**CERTIFICATE OF APPROPRIATENESS**

**Property:** 1911 B Crockett St, Lot 5, Block 1, Barclay Estates Subdivision. The property is a vacant interior lot, subdivided into two lots, Lot A measuring 2,604 square feet (42' x 62') and the Lot B measuring 1,596 square feet (42' x 38').

**Proposal:** New Construction – Residence/Garage *Deferral*

Construct a two and a half-story 2,274 square foot residence and attached garage.

**NORTH ELEVATION – FRONT FACING CROCKETT STREET**

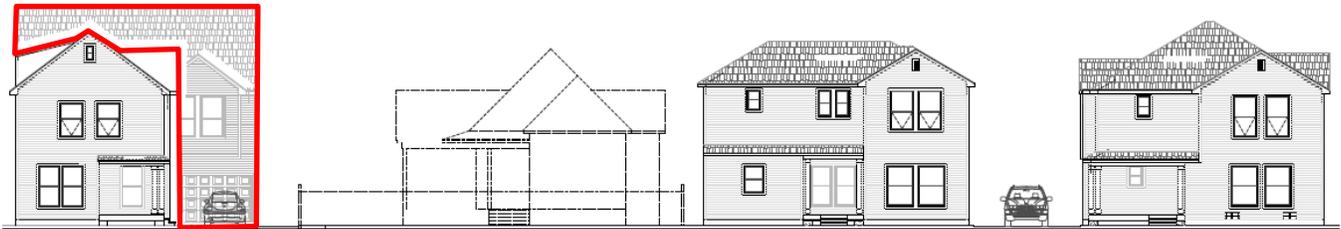
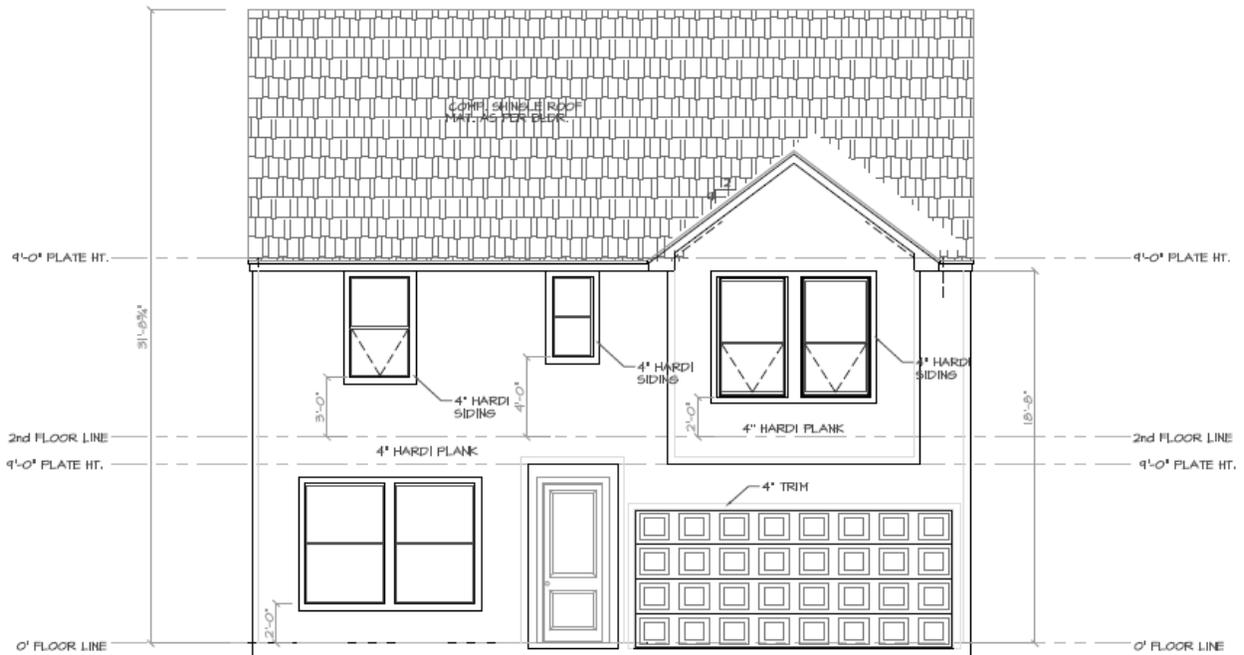
- 2.2. In addition, several of the proposed structures (1911A, 1911B, 1913B) stretch the definition of what can be considered a two-story structure. By incorporating dormers (in order to capture additional living space in an area which in a traditional historical structure would be an unfinished attic), they create additional massing, worsening the contrast with and dwarfing of 1907 Crockett and the other contributing structures. These proposed new buildings are really two-and-a-half-story structures.

- 3.1. 8" hardie plank has been specified throughout. This material is cheap-looking and not in keeping with the historic structures in the District. 4" plank should be used instead. Additionally, the texture of the planks to be used is not noted; flat-texture planks should be used.
- 3.2. Glass block has been specified in all of the designs. This material does not seem appropriate for a historic district.
- 3.3. Many of the windows in the designs are large, single-pane fixed windows. This type of window does not seem appropriate to this historic district. 1-over-1 and 2-over-2 double-hung windows are the norm in this district.

SITE PLAN

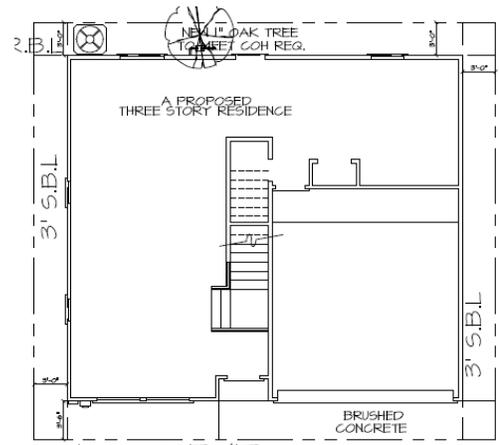
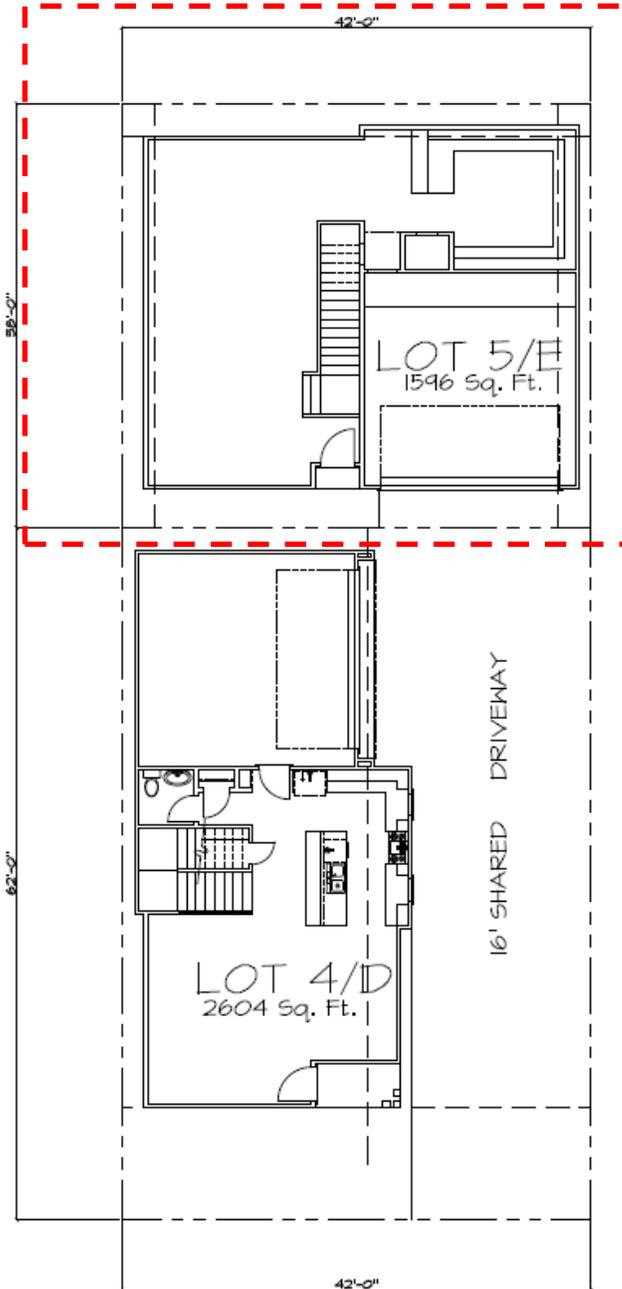
- 1.1. A site plan is required for a COA application. Each of these applications includes a drawing labeled "Site Plan". However, these purported site plans do not indicate the orientation of the proposed buildings to the surrounding streets or to each other. In addition, the elevations are listed as "left", "right", etc. instead of the usual "north", "south" etc. All this is contrary to industry standards, and makes the site plans are very difficult to decipher. This needs to be addressed in order to make the proposed plans more readily understandable.

- 1.2. Given the close proximity and interrelationships of the proposed buildings with one another, a site plan should be provided that covers all the buildings in the project so that what is being proposed can be understood.

- 1.3. With respect to the applications for 1911A and 1911B Crockett: according to the records available online, the 5,000 square foot lot in question is platted into 3 lots, so one might have expected to see applications for 1911A, 1911B and 1911C. However, no COA application for 1911C appears to have been made. Are we to understand that the 5,000 square foot lot is being replatted into two instead of three, i.e., that 1911A and 1911B are going to take up the full 5,000 square feet? This is another point that the site plan should have made clear, but doesn't.
